**Declaration**

Section 57 Declaration – Works to a Protected Structure

Reference No: S57 DB23-02

Re: No 1 & 2 Paradise Place, Drogheda, Co. Louth – Gable Wall and Southeast Corner.

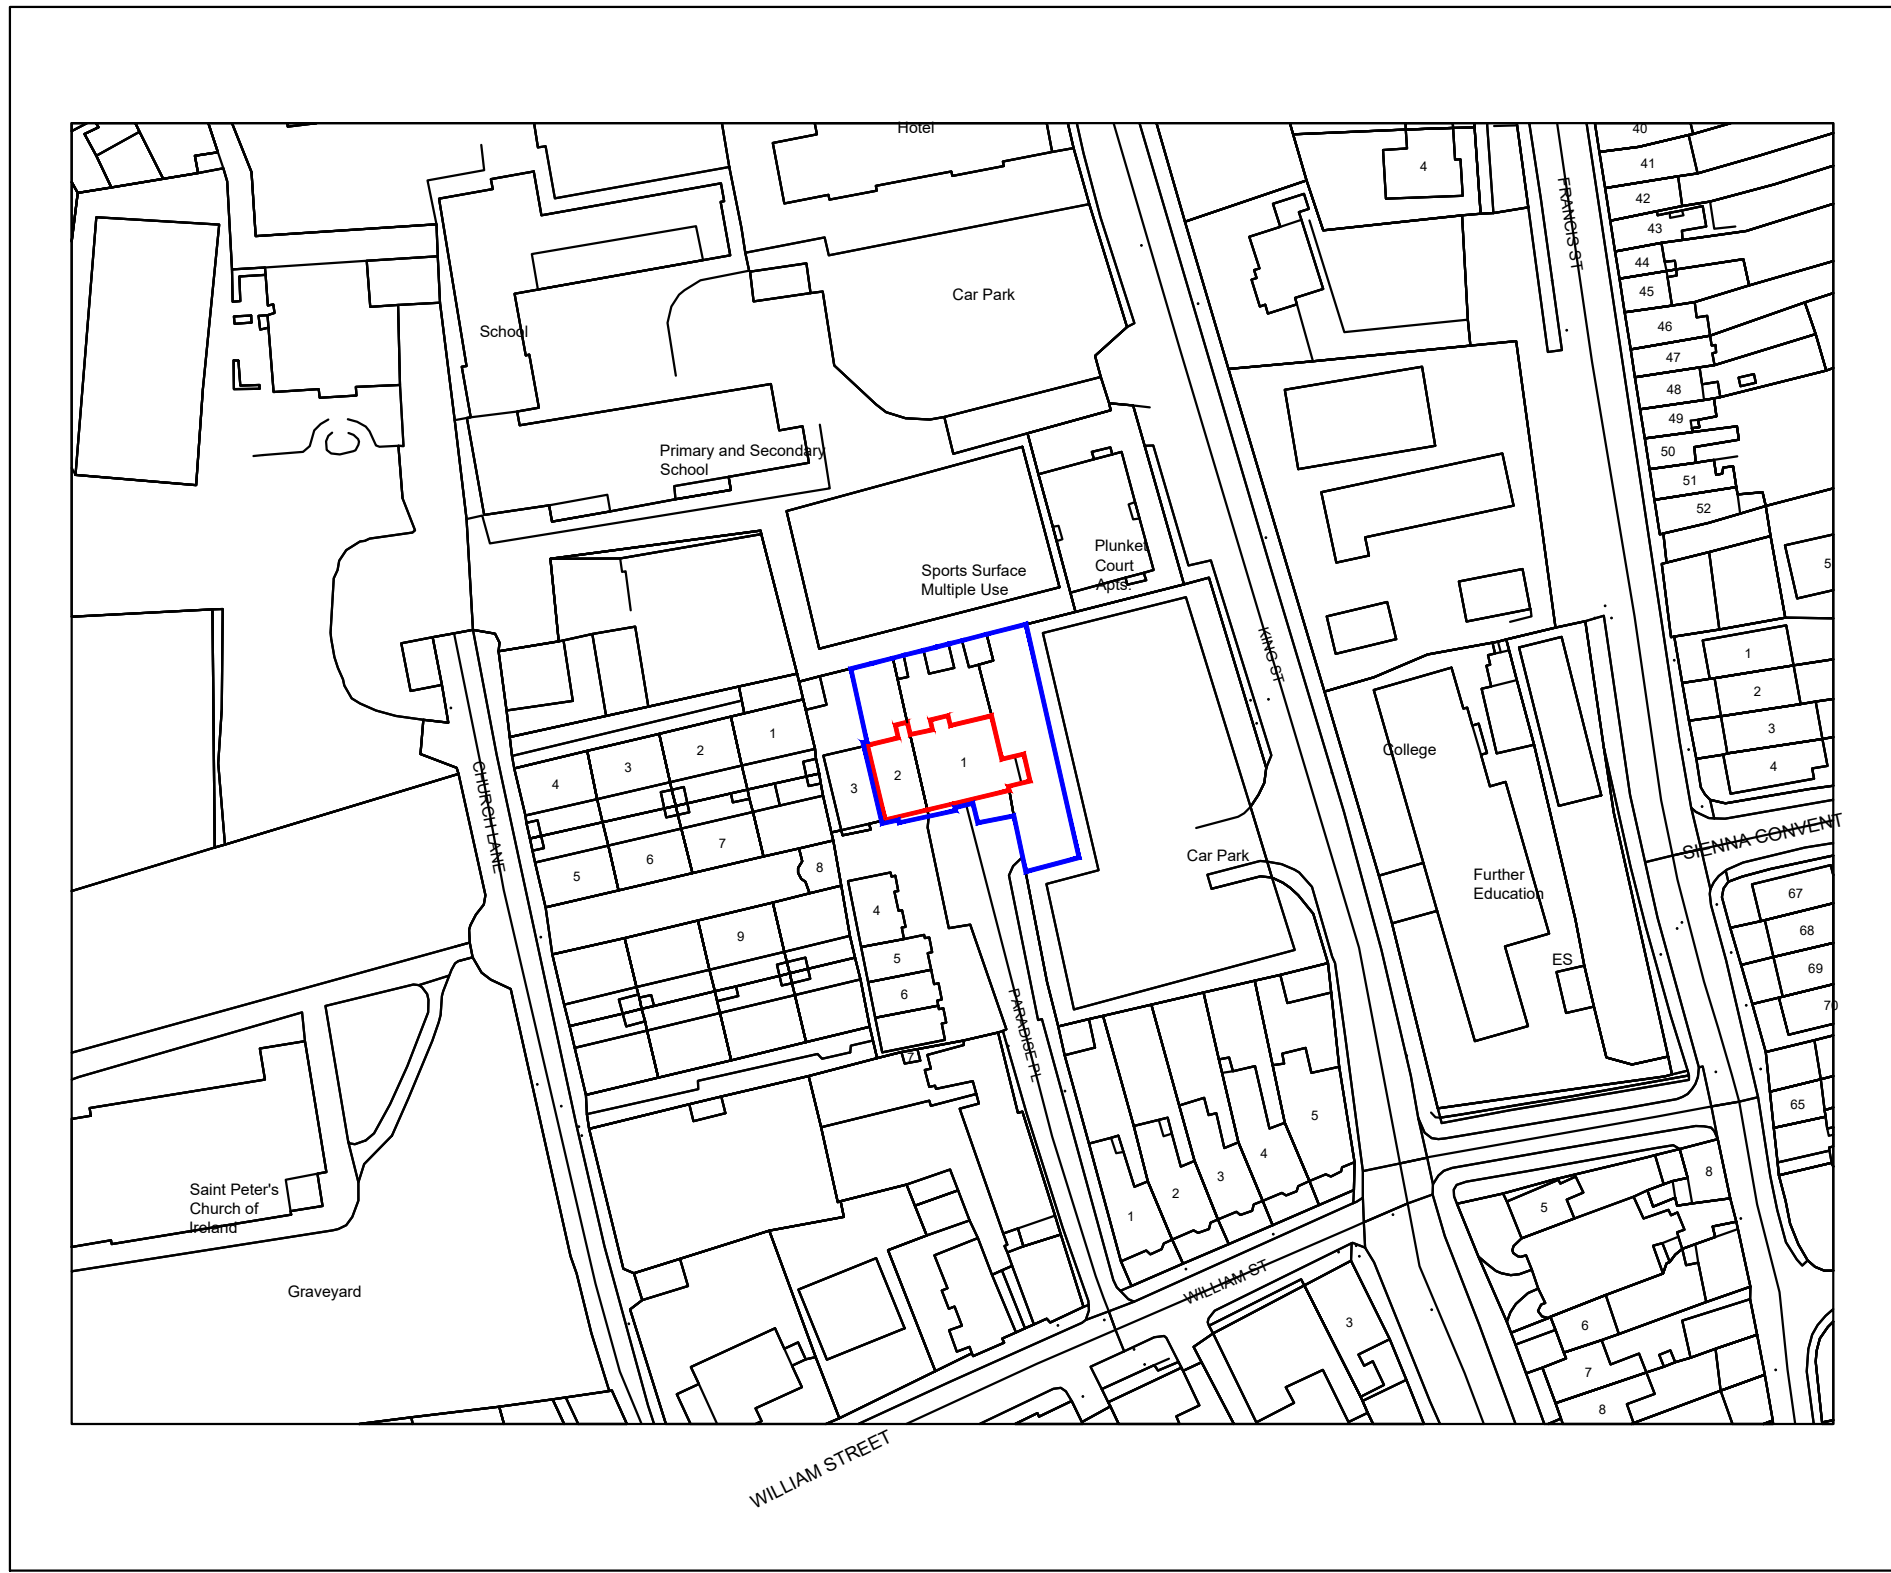
It is proposed that the following works are carried out on the gable wall:

1. Remove all cementitious materials.
2. The chimney stack material is numbered and deconstructed layer by layer.
3. The gable wall material is number and deconstructed level by level.

4. The gable wall is reconstructed to match existing, using the existing materials such as brick and stonework. No reclaimed brick from other sites may be used. Any damaged brick is to be replace with engineering brick.

5. Helibars are to be installed to ensure the gable wall and the front & rear wall are all tied together.
6. Mortar samples are to be carried out and the new mortar mix is to match existing.
